## **Reviewer #1 (Remarks to the Author):**

Review of “An International Intercomparison of Continuous Flow Analysis (CFA) Systems for High Resolution Water Isotope Measurements in Ice Cores” by Agnese Petteni et al.

Fig. R1. d18O and dD continuous analysed (top) at different humidity levels (bottom)

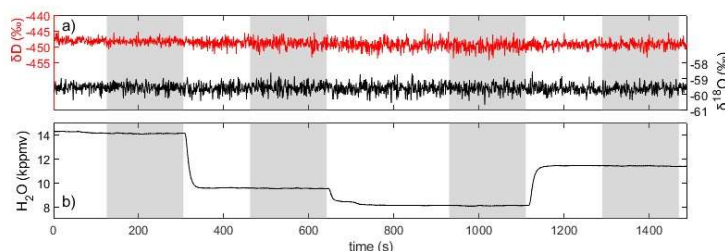
- 1) Despite the (surprising) small differences with the other systems' results, the very low humidity level of the ISP-UNIVE CFA may most likely be source of the (1) increased measurement noise shown by the Allan deviation test, and especially (2) a bias in the measurement as water vapor mixing ratios below <15000ppm leads to non-linearity in the instrument response (Gkinis, 2010). I agree that the instruments used in this study give better performances than the one used back then, which likely explains why the results are that good. Nevertheless, Fig 3 clearly shows a significant trend towards higher value (especially for dD and thus also dexcess), and I would be very surprised if the measurement stays the same at 20000ppm... Thus, to me the conclusions using these data are questionable in the current state.

We agree that the ideal measurement range for the Picarro instrument is around 20,000 ppmv, rather than 10 to 14,000 ppmv conditions. We were obliged to work at this level at ISP-UNIVE, as the water flux provided at the vaporizer did not allow us to reach higher constant humidity levels. And indeed, since modern Picarro instruments do not show strong non-linearity in the instrument response down to 10,000 ppmv now (for instance Aemisegger et al, 2012 compared a L1115i to a L2130i and really showcase the improvement compared to 2010), a big part of the bias is removed, but still, the precision of the instrument is going to be lower at the humidity levels we studied compared to 20,000 ppmv. In the updated manuscript, we will provide Allan variance plots at different humidity levels to illustrate which part of the lower performances of the Venice setup can be explained by the lower humidity.

The new figure will include similar data to the figure below, but for longer time intervals:

Fig. 3. Mean  $\delta^{18}\text{O}$  and  $\delta\text{D}$  values for the 3-minute intervals selected at humidity level of 8,000, 9,500, 11,500 and 14,000 ppmv in the ISP-UNIVE setup (Fig. R1 - grey intervals). The confidence levels are defined as the Allan Deviation for integration time of 1 s ( $\pm 1\sigma$ ).

This will also allow us to assess the potential trend toward 20,000 ppmv, extending Fig. 3 (above right) to cover higher humidity levels. Based on these new results, we will more accurately determine whether a correction of the ISP-UNIVE record is necessary.
